RCSC Middle School **Natatorium HVAC & Lighting Upgrade**

Project # 2023.0011

05-20-2024

ADDENDUM NO. 01

SHEET
A10.1

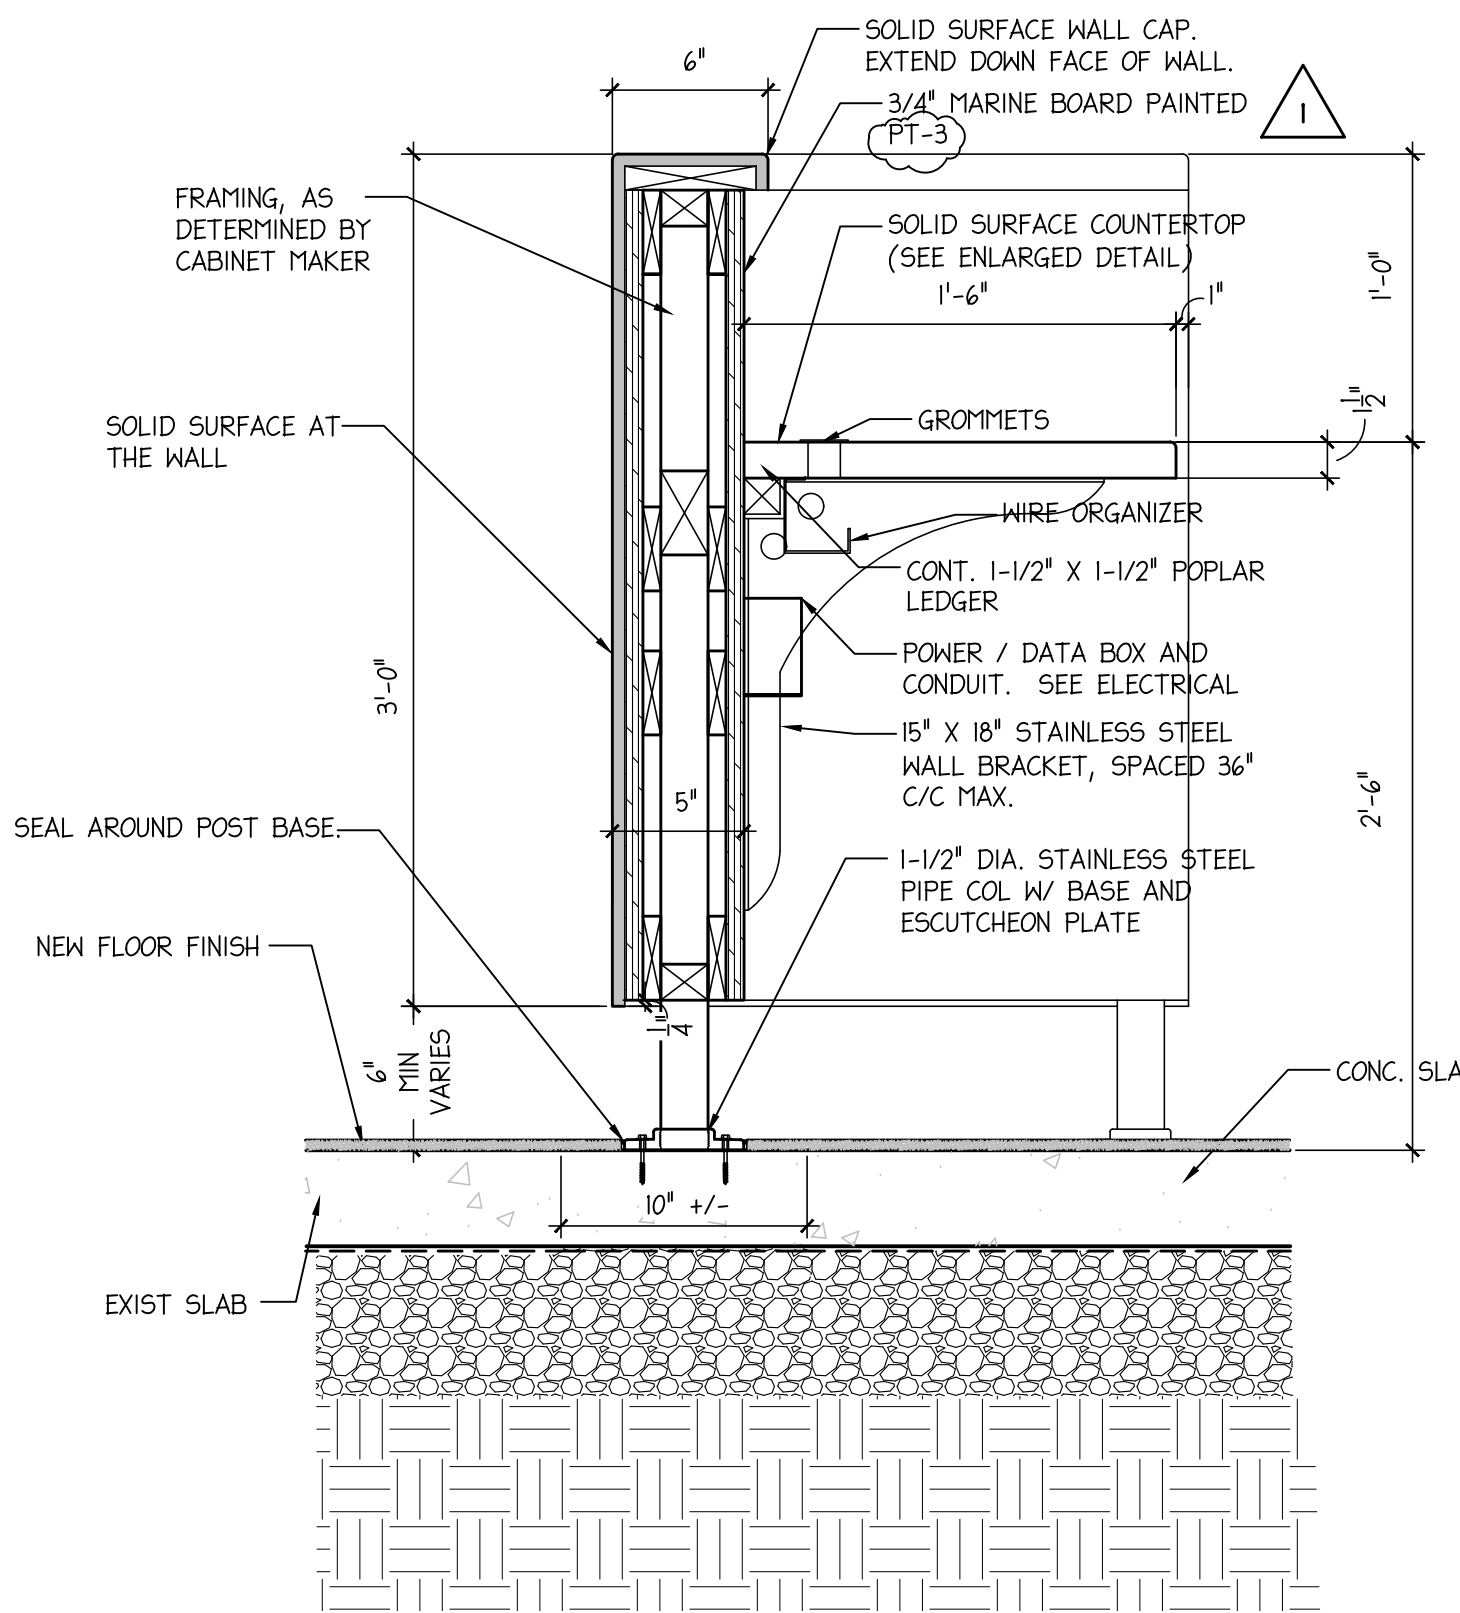
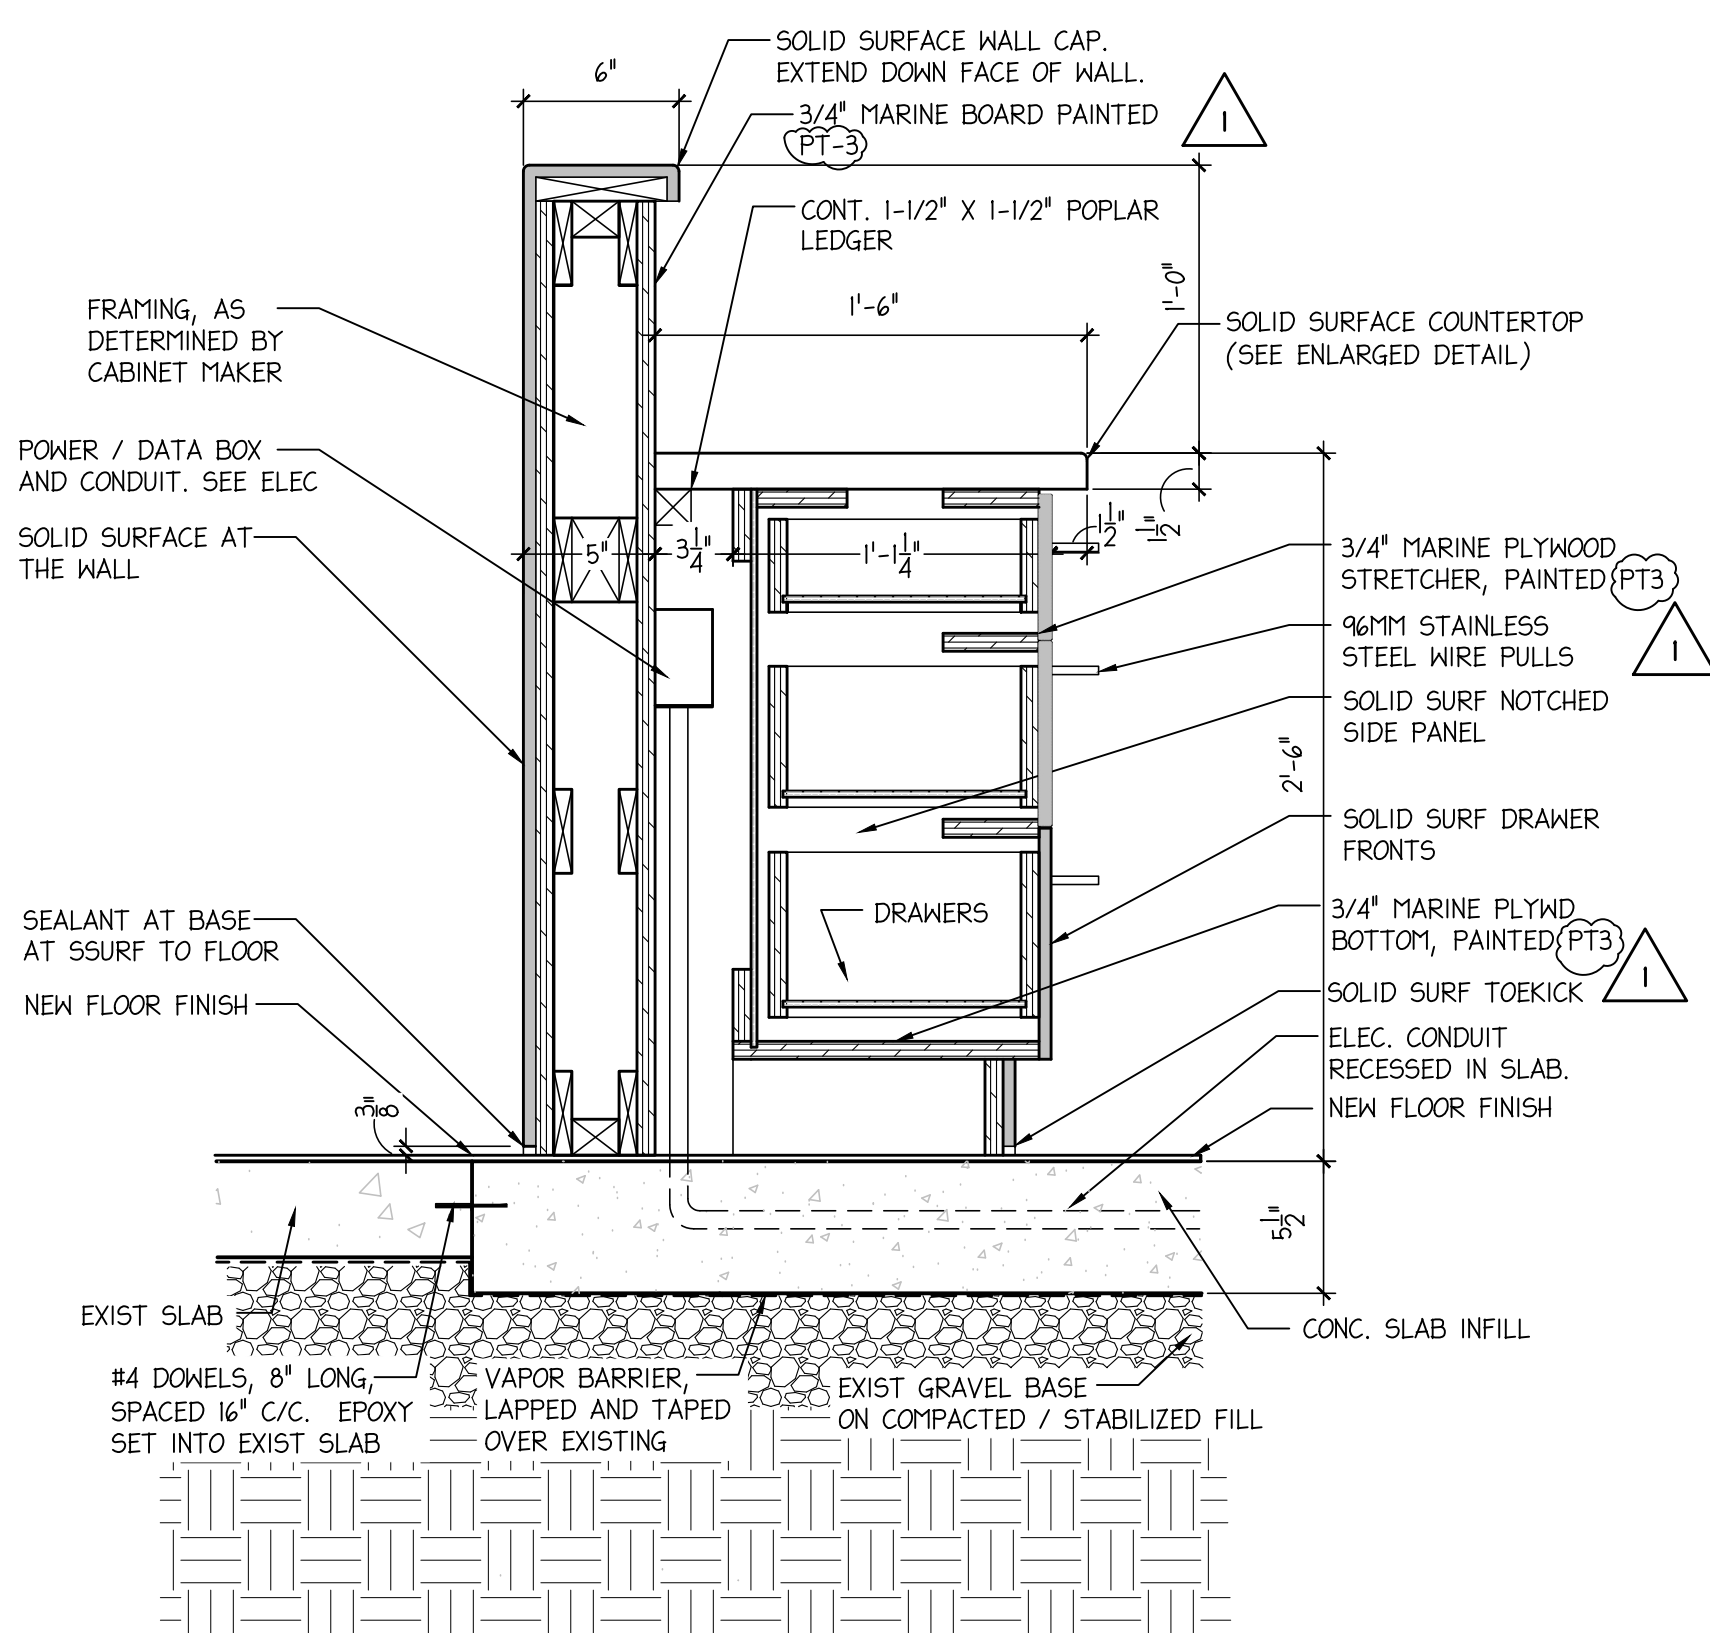
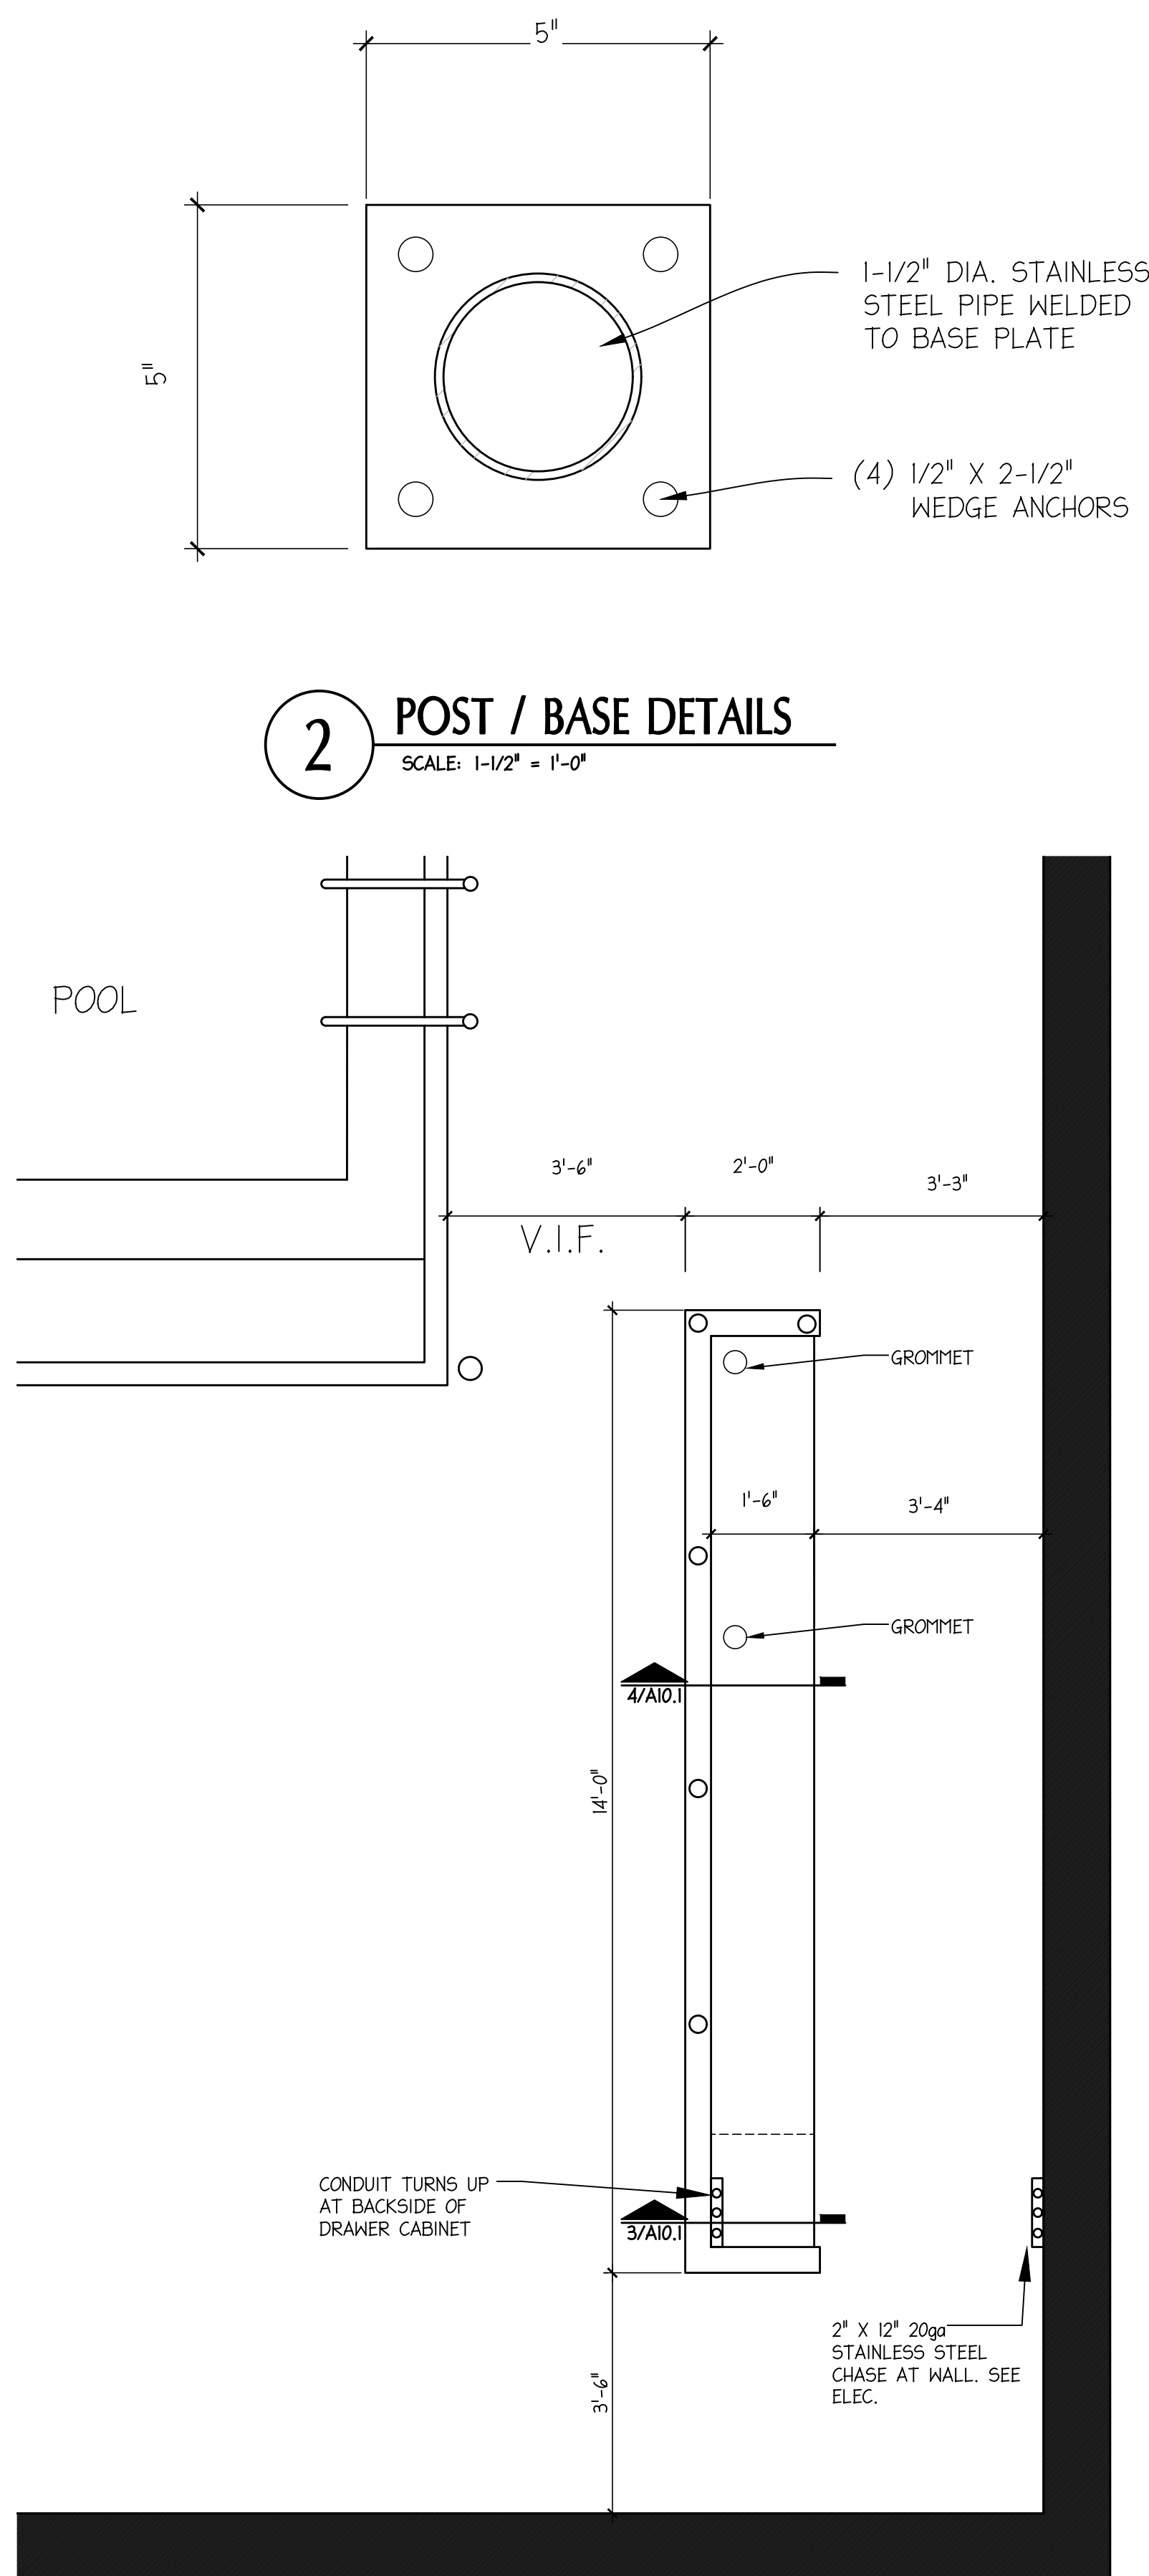
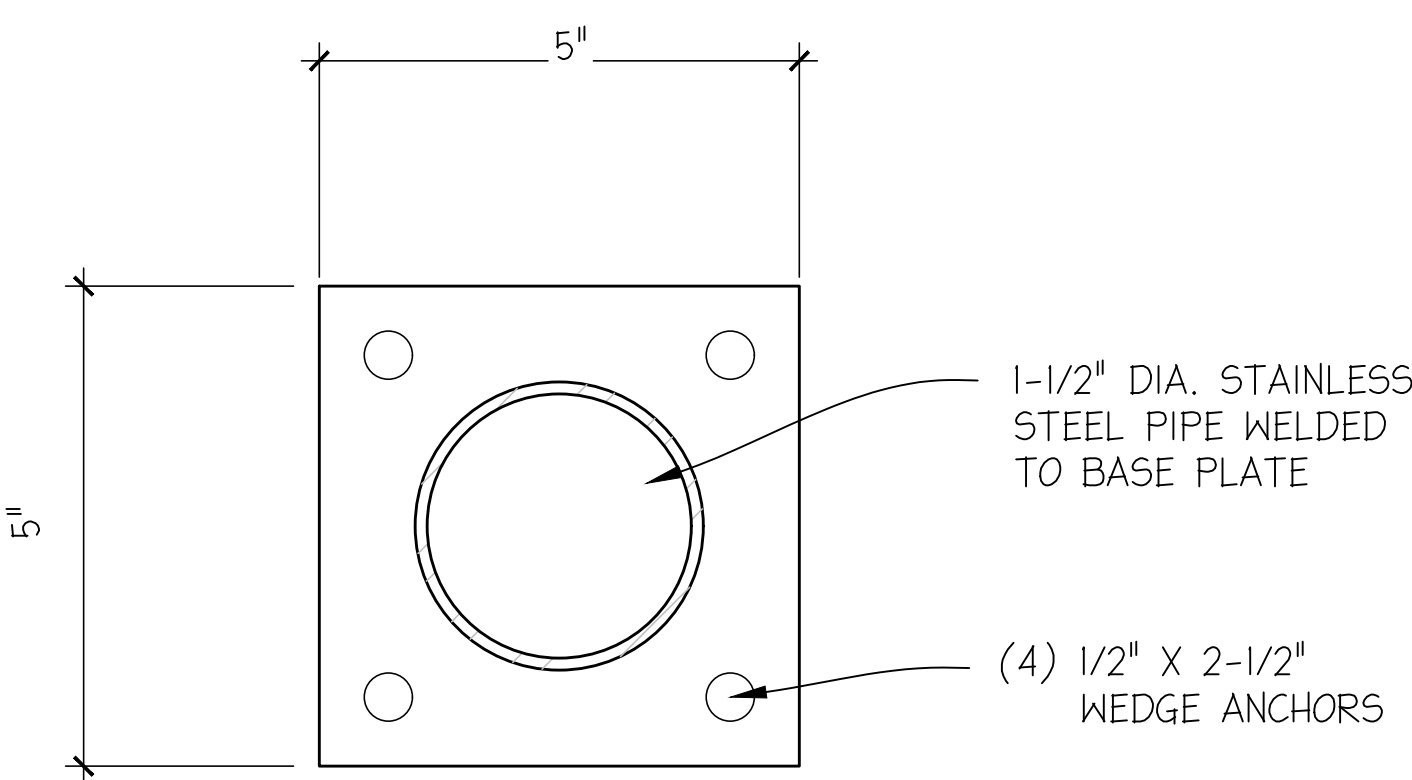
Item: **A-1.9**
Location: A10.1 Casework Details
Description: Replace drawing dated 05-01-2024 with drawing marked Addendum 01, dated 5-20-2024

1. Updated colors on casework.
